Village of Arlington Heights
Plan Commission
Board Room, 3rd Floor
Arlington Heights Village Hall
33 S. Arlington Heights Road
Arlington Heights, IL 60005
April 10, 2019
7:30 PM

- A. Arlington 425 - Highland/Campbell/Chestnut - PC#19-001
Planned Unit Development, Preliminary Plat of Subdivision,
Rezoning from R-3 to B-5, Land Use Variation to allow a Multi-
Family use within B-5 District, Variations
- B. Yamada America - 955 E. Algonquin Rd. - PC#19-002
Amendment to Rezoning Ordinance 81-112, 82-146, 89-027, and
92-011, Variations

RE: ARLINGTON 425 - HIGHLAND/CAMPBELL/CHESTNUT - PC# 19-001
PLANNED UNIT DEVELOPMENT, PRELIMINARY PLAT OF SUBDIVISION,
REZONING FROM R-3 TO B-5, LAND USE VARIATION TO ALLOW A MULTI-
FAMILY USE WITHIN B-5 DISTRICT, VARIATIONS

Sheet
A0.0
_ of _ sheets

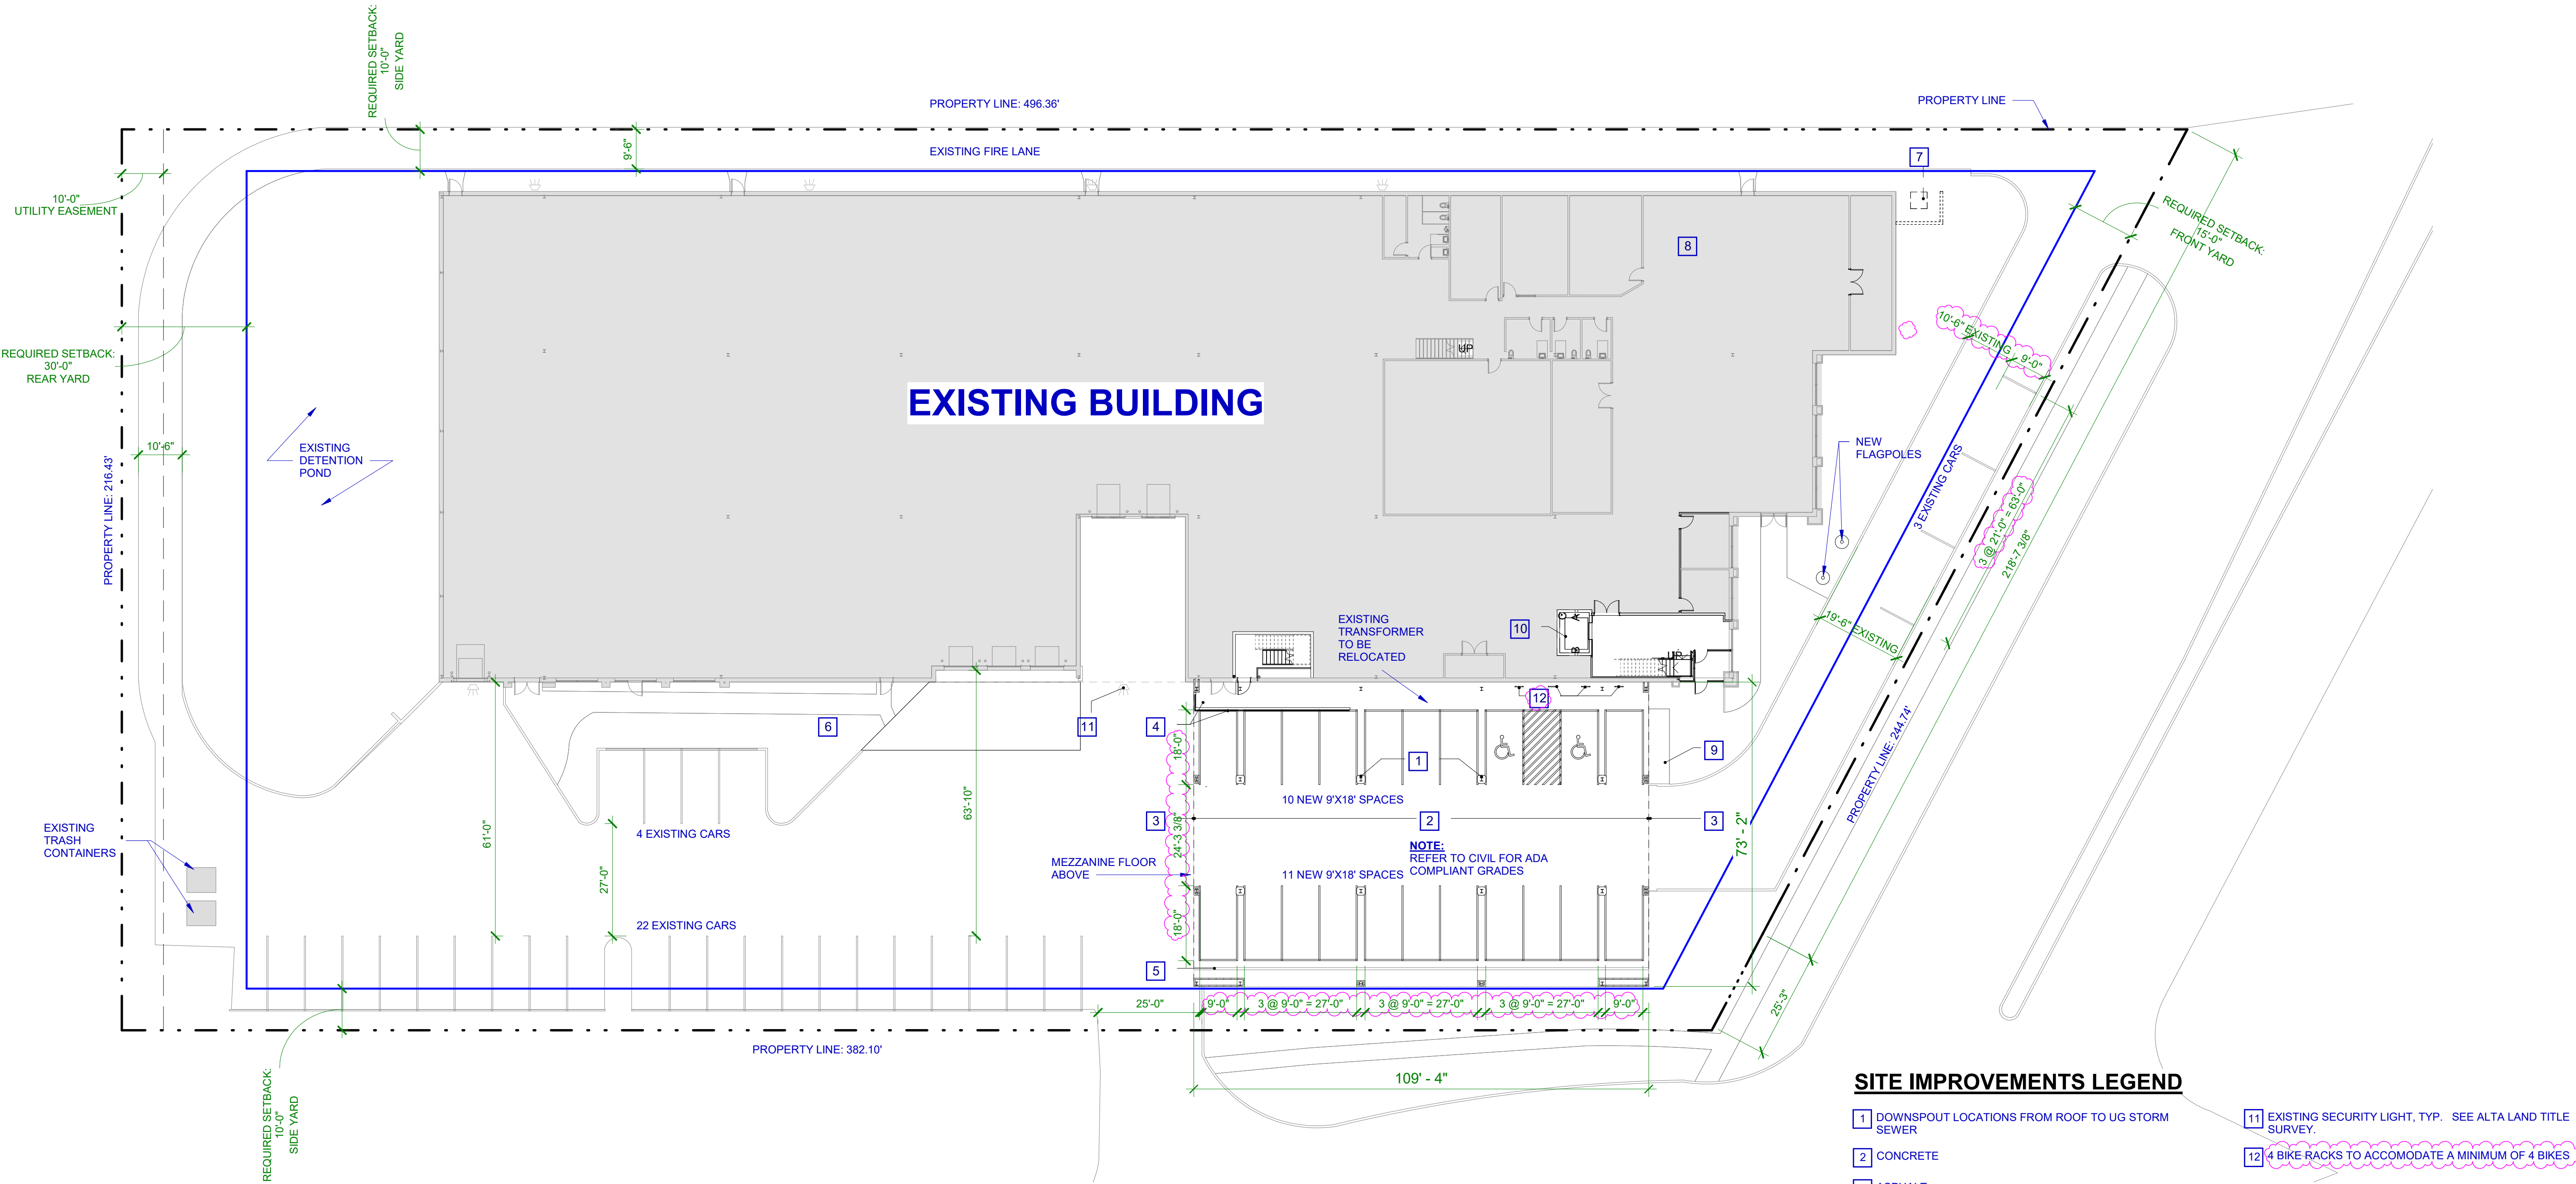
13. Sheet A1.0 includes a label "12" (Bike Racks), however, there are no bike racks shown on the site plan. Please show the location of the proposed bike racks and clarify how many bicycle parking spaces will be included within the racks. A total of 4 bike parking spaces are required.

16. Does the total size of the office portion of the building still match the size as previously contemplated, per my 12/18/18 email? It appears that there are discrepancies between what is listed on sheet A1.0 in the building data square footages and the parking calculations. Additionally, the description in the parking calculations do not appear to include the 2nd floor stairway. Please include a breakdown of all office spaces included in the calculation, as well as a floor plan showing these spaces per comment #10.

17. Three handicap accessible stalls are required for parking lots that include 51-76 parking stalls.
18. The project narrative indicates that there are 15 warehouse employees, however, the parking calculations on page A1.0 indicate that there are 17 warehouse employees. Please clarify and revise the plans/project narrative accordingly.

11. Parking stall LxW dimension, and drive aisle width have been added to sheet A1.0 for the parallel parking stalls at the north end of the property. The parking spaces along the front has been revised to 3 from 4 to maintain a max total of 50, which exceeds the 46 minimum spaces required.

12. There are two possible transformer locations indicated on sheet A1.0. The east side of the building location is noted as the preferred location (see keynote 6 on that plan) subject to ComEd approval. If this does not work for ComEd, the alternate location would be on the north side (see keynote 7 on that plan). The Landscape Plan L1.0 has been revised to reflect the same layout as A1.0. An existing tree at this location would be affected by this alternate location so a clouded alternate replacement trees have been also indicated). Additionally, the planter at the northwest corner of the building addition on Landscape Plan L1.0 has been revised to reflect the same layout and size as shown on A1.0 and the civil engineering plans.

13. The Site Improvement Legend on Sheet A1.0 uses numbers in boxes as keynote targets. There are 4 individual bike rack shown along the building The bike rack keynote target has been corrected to read "12", and not 1. Additionally the Legend keynote has been revised to indicate "4 bike racks to accommodate a minimum of 4 bikes".

14. The Site Improvement Legend on Sheet A1.0 has been revised to include a description of the "Alternate transformer alternate: brick screen wall to match transformer height, TBD". We are waiting for ComEd's specs on the transformer size.

15. The unlabeled feature was removed from A1.0. It was the proposed location of the transformer in an earlier iteration.
16. The areas on my 12/18/2018 email to S. Hubbard, areas are described as existing areas (i.e., 42,422 sf building footprint plus mezzanine areas, and 38,709 sf building footprint only). A1.0 is consistent with that. However, after review of area calculations a few minor errors were found. The Areas and Parking Calculations have been corrected accordingly on revised A1.0 with a corrected breakdown of the areas and the parking calculation.

17. Understood, although we do not expect the required parking total to exceed 50.
18. There are 17 office and 15 warehouse staff. The narrative is correct. The parking calculation was in error. Drawing A1.0 has been corrected.
